## PLANNING & ZONING COMMISSION

- A. **Request for Site Plan;** Chick fil-A (project name); US Hwy 441 (Site Address); Simpson Family Partnership, LTD. (Owner); Bohler Engineering FL, LLC (Applicant); Bohler Engineering FL, LLC; MLD Studio Landscape Architecture (Landscape Architect); GDP Group (Architect). Project No. SP24-11.

- B. **Request for Site Plan;** Freddy's Frozen Custard & Steakburgers; Eudora Road (Location); Eudora Road, LLC (Owner); Eudora Road, LLC (Applicant); Germana Engineering & Associates, Inc. (Engineer); Green Consulting Group, Inc. (Landscape Architect). GMLV Architecture, Inc. (Architect). SP23-08.

**RE:** **Application for a Minor Site Plan: Chickfila, Mount Dora Groves South PUD (Project Name)**, 19360 US Highway 441, Mount Dora (Site Address); Andrew J. Hupp, One Oak MD Groves, LLC (Property Owner); Kyle Morel, Bohler Engineering FL, LLC (Applicant and Engineer); Aaron Neitzke, MLD Studio Landscape Architecture (Landscape Architect); Erik Rios, GPD Group (Architect).  
**Project No. SP24-11**

| NO.              | DATE       | DESCRIPTION                                     |
|------------------|------------|-------------------------------------------------|
| SHEET C600       |            |                                                 |

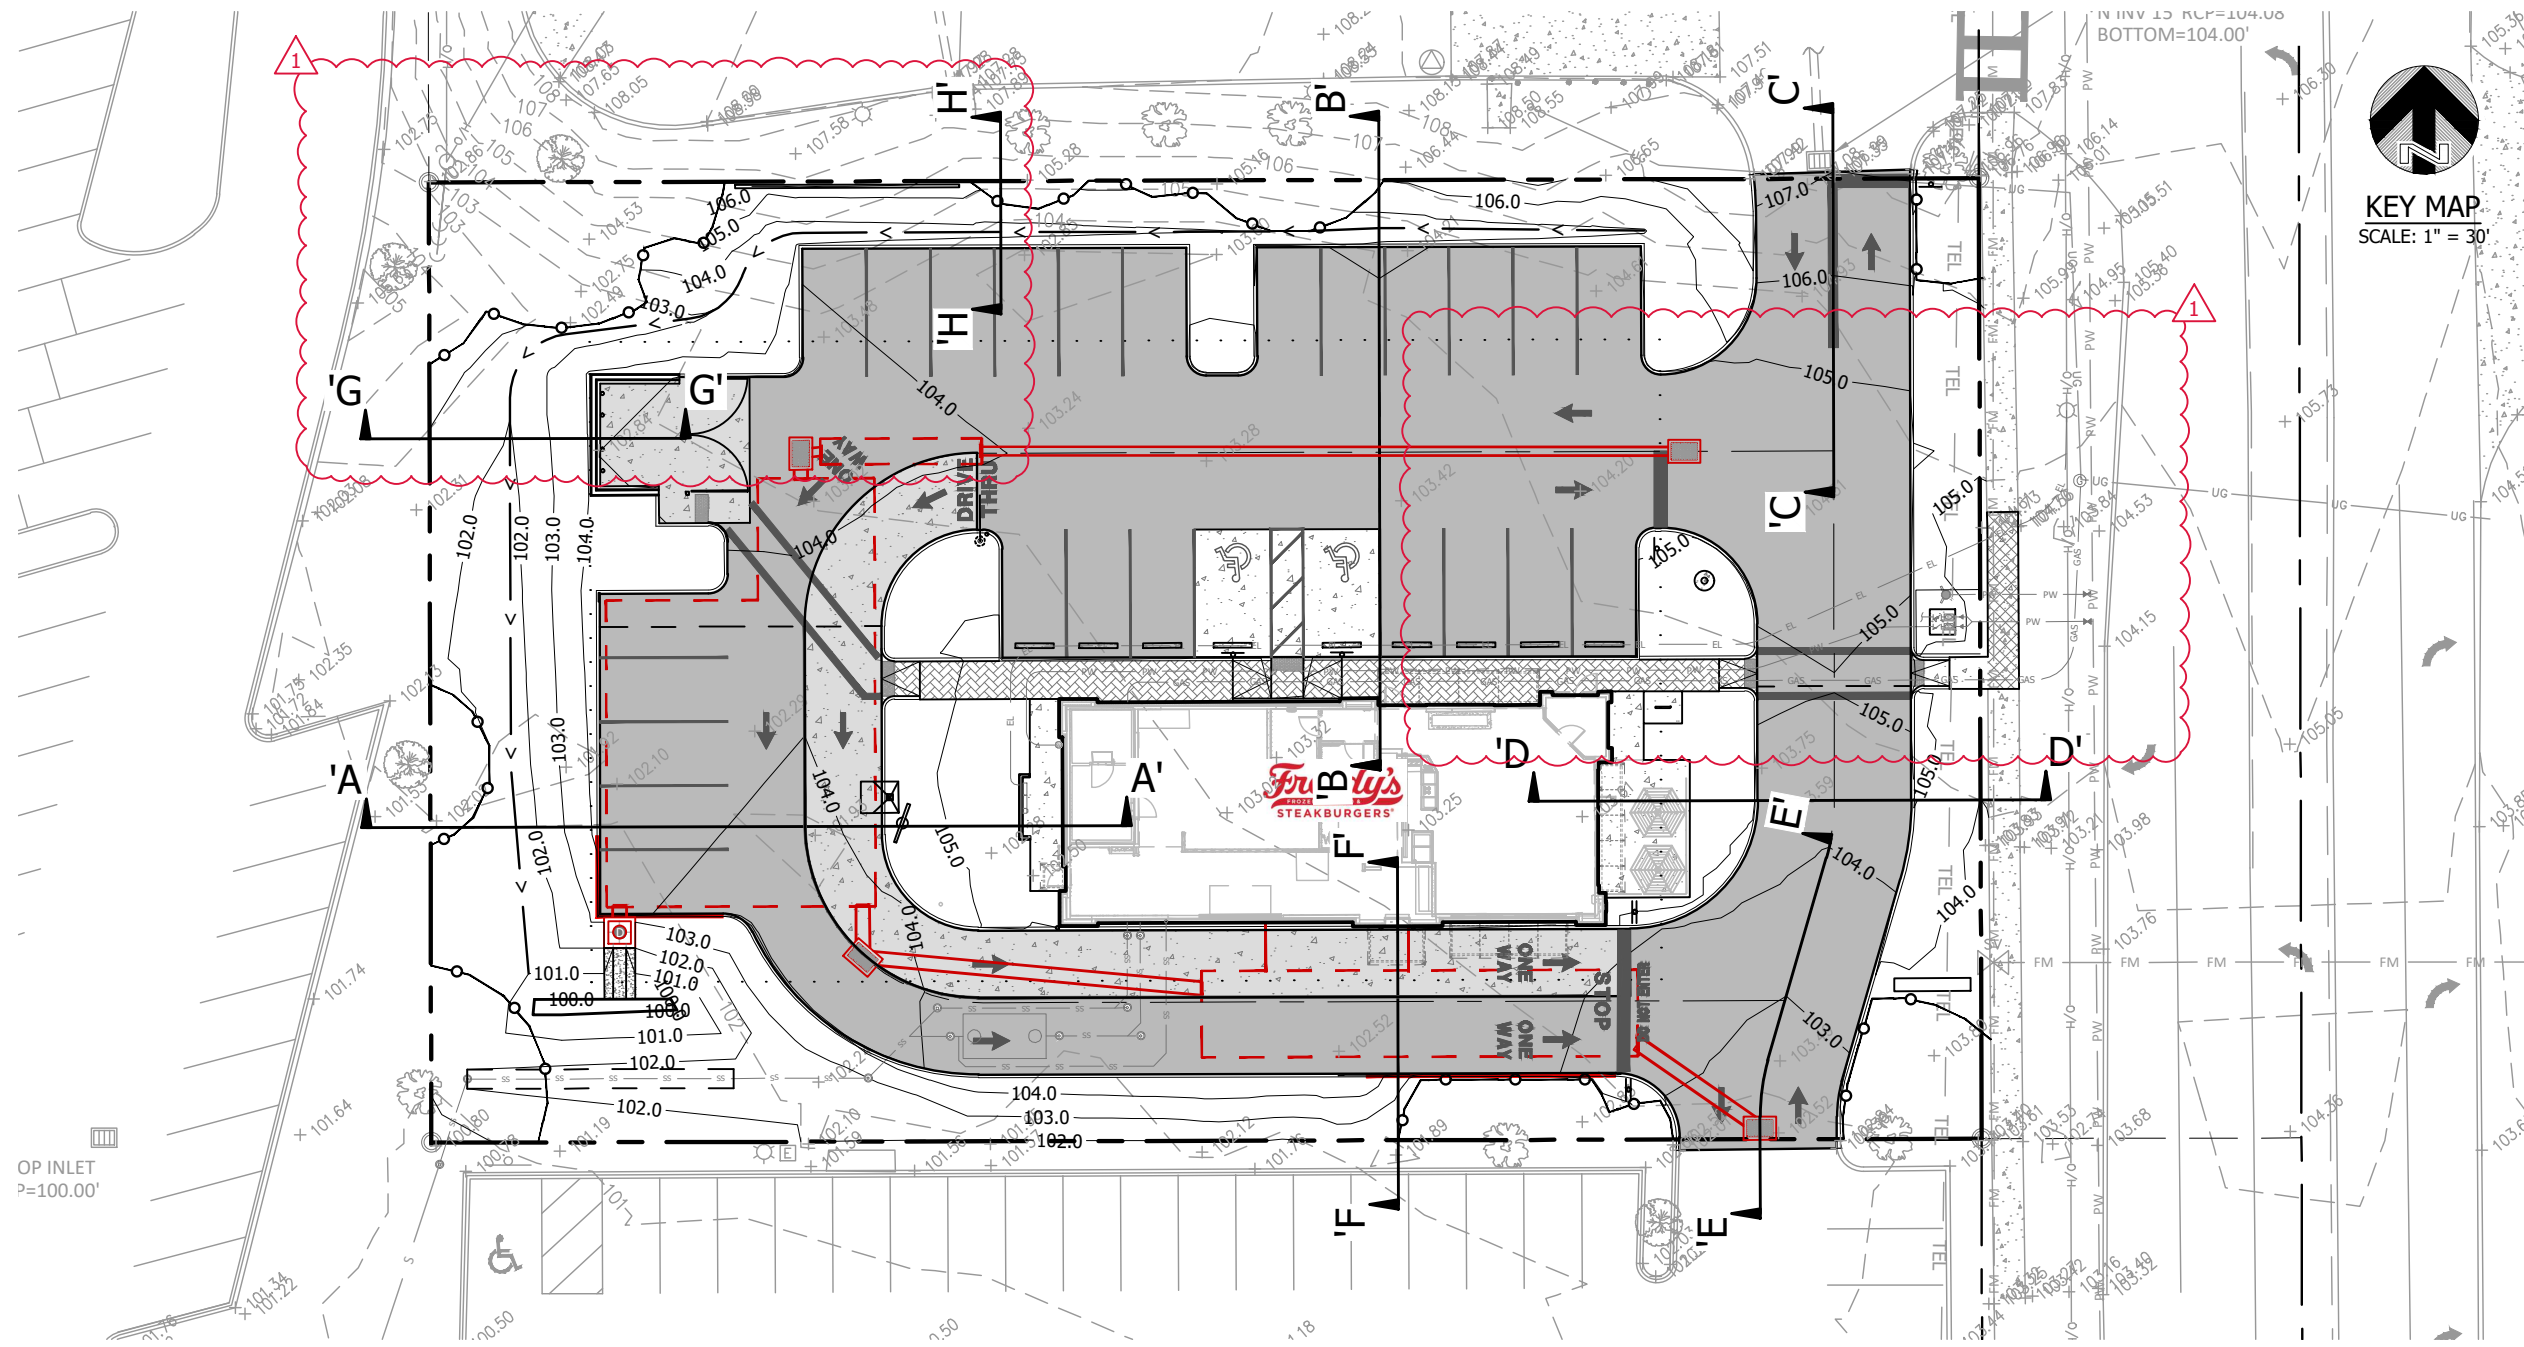
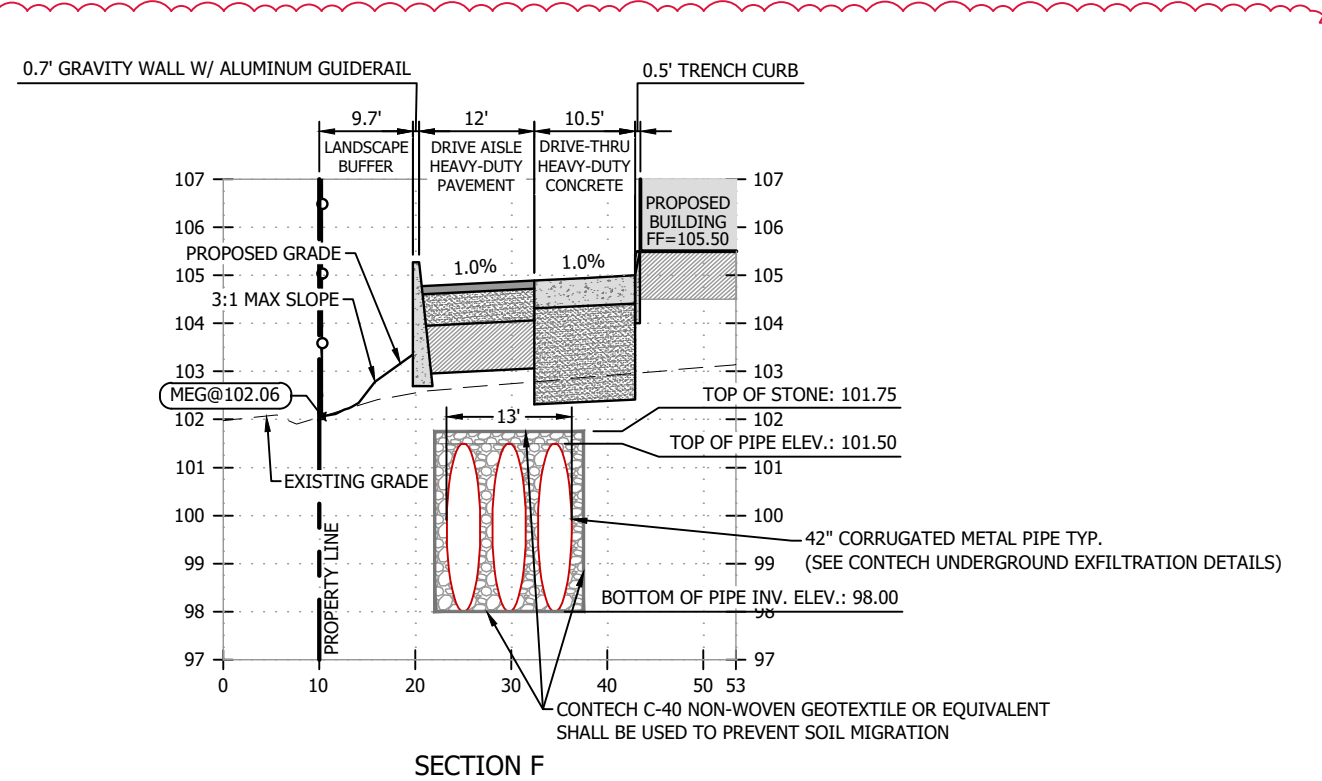
Comment 62: Callout the filter fabric that will be used to wrap the 42-inch corrugated pipe in sections A and F (not called out on sheet C702).

**Response 62: The filter fabric has been added/called out on sections A and F. See revised sheet C600.**

**Response 63: This section has been revised as requested. See revised sheet C600.**

**Response 65: The note in this section has been corrected. See revised sheet C600.**

LP501

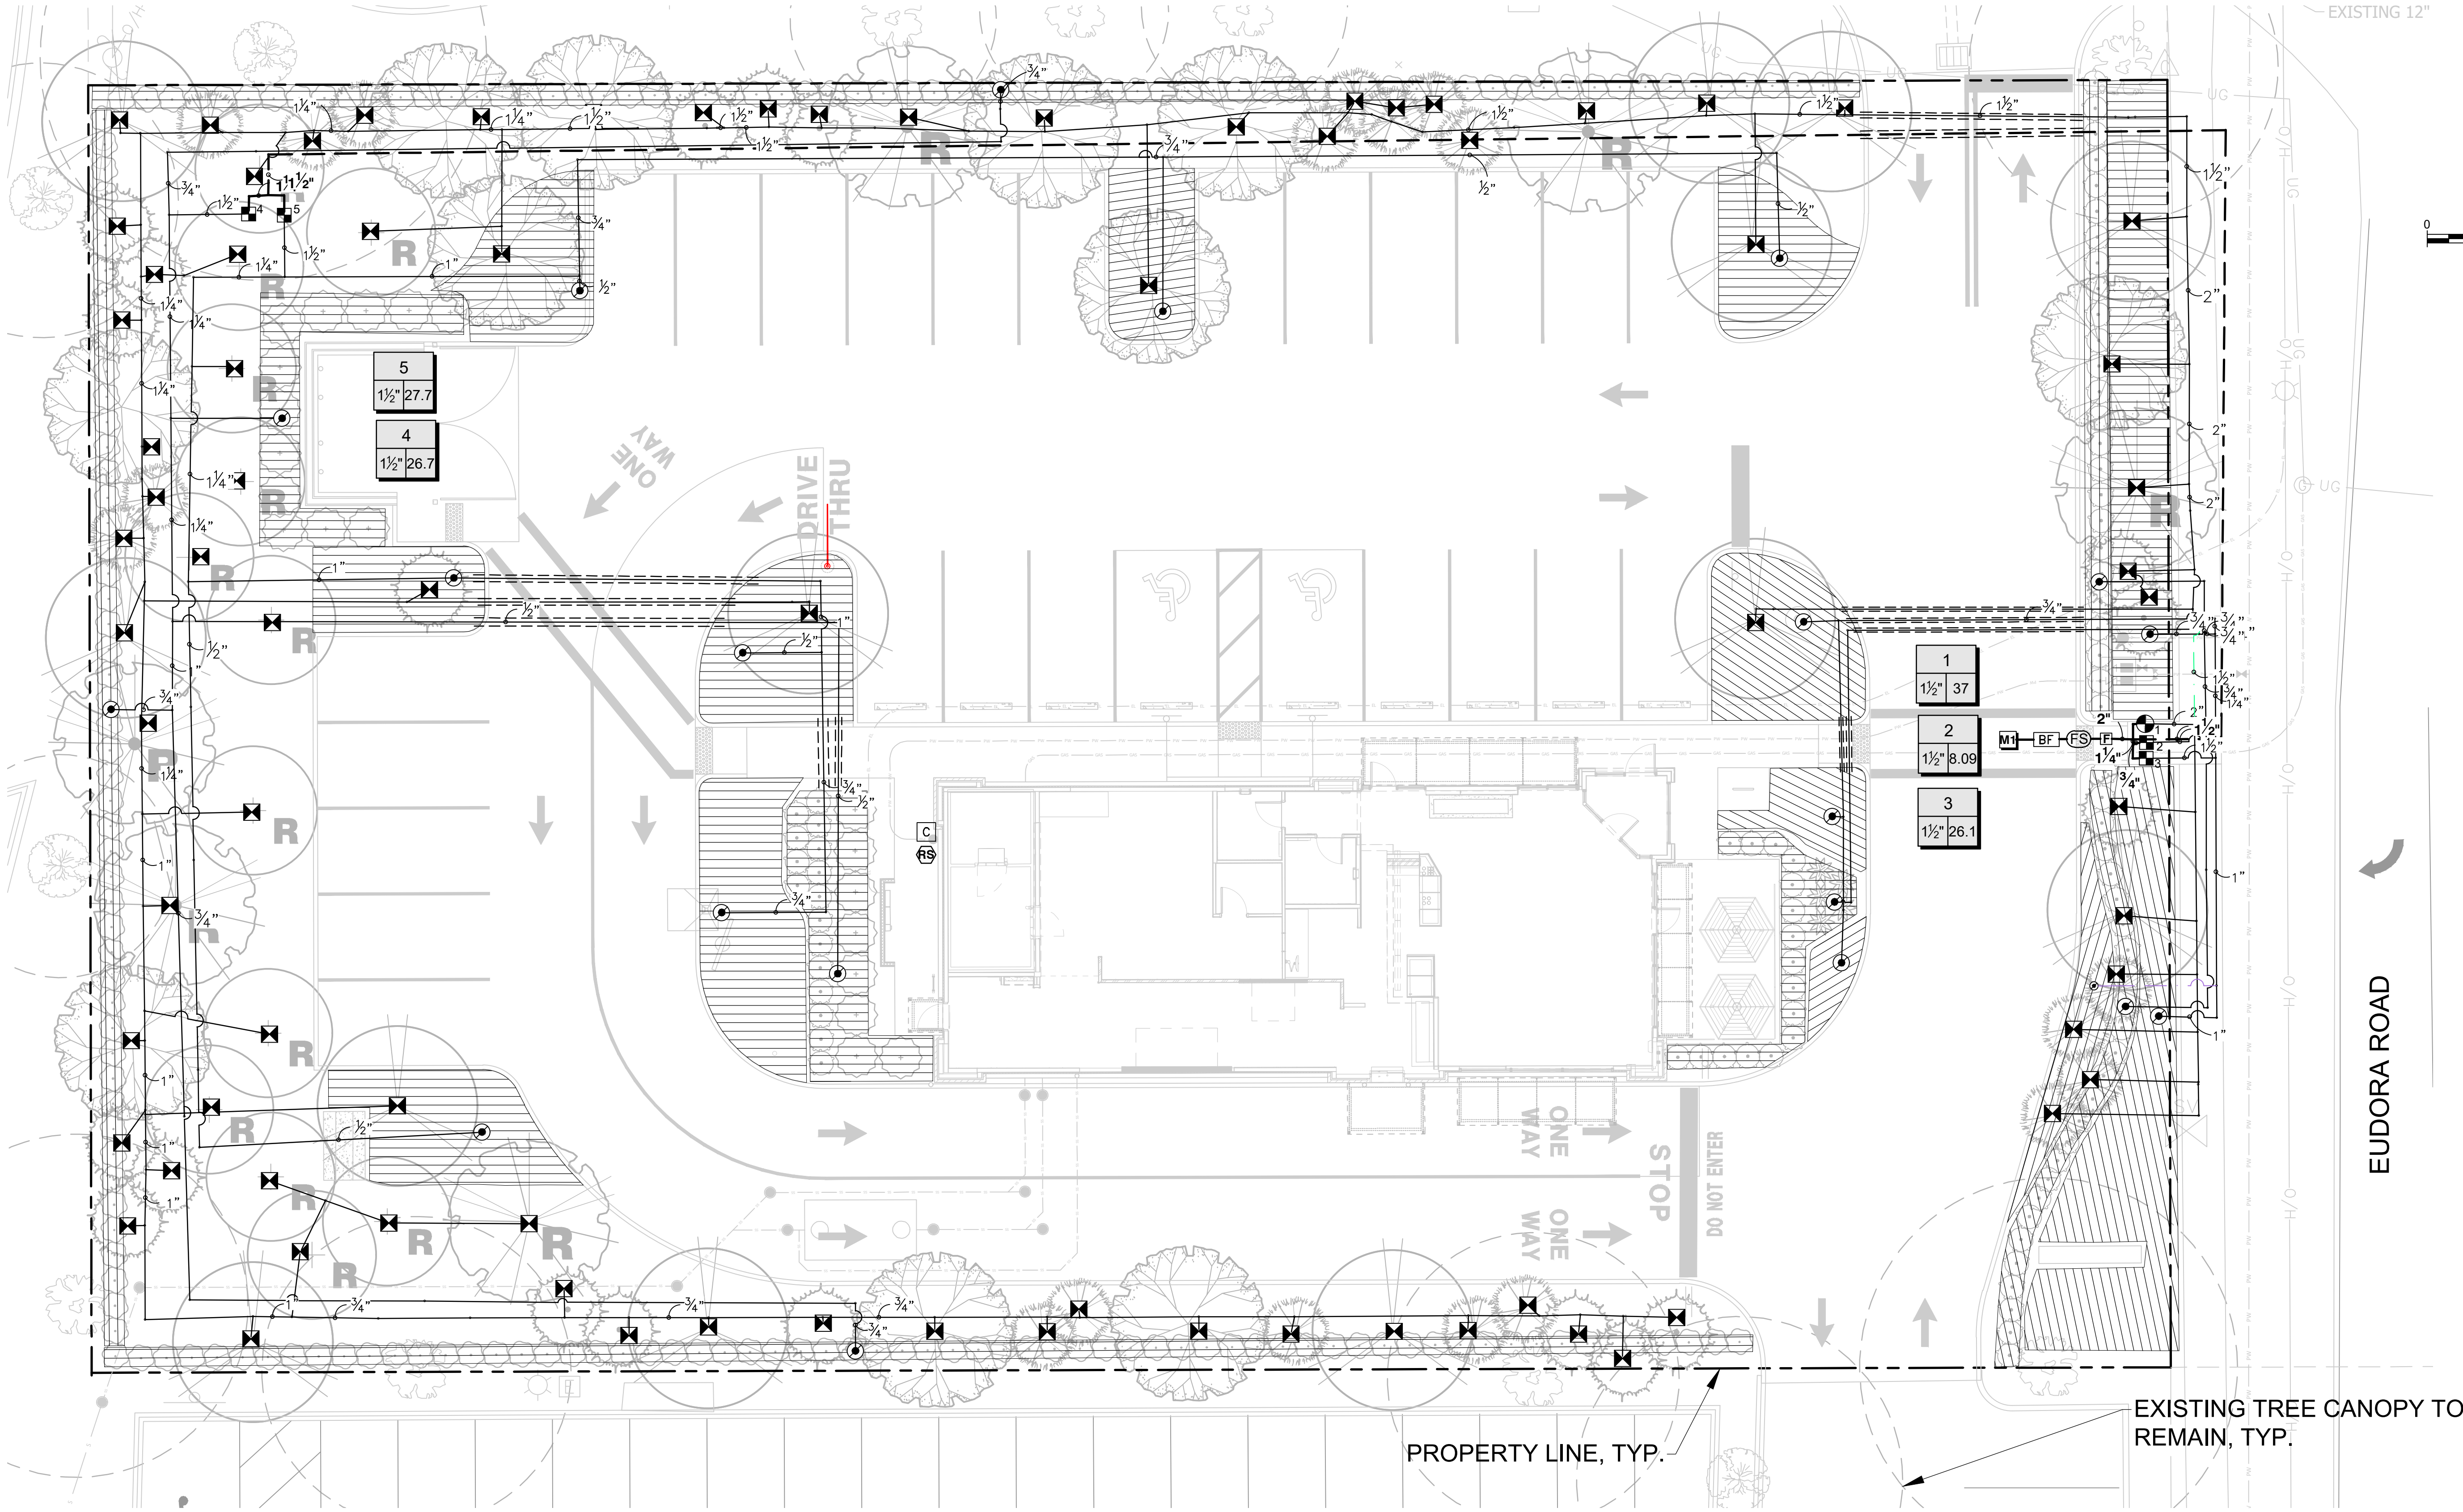
**Comment 1:** Plan Sheet LM100 indicates that 23 replacement trees will be mitigated on site and refers to Plan Sheet LP502; Plan Sheet LP502 was not included with the landscaping plans. Please revise the Landscape Plan to depict where the removed trees will be mitigated.

**Response 1: Updated reference on plan sheet LM100 to LP501 for mitigated replacement trees. Landscape plan (LP100) has been updated and depicts replacement tree locations for mitigation.**
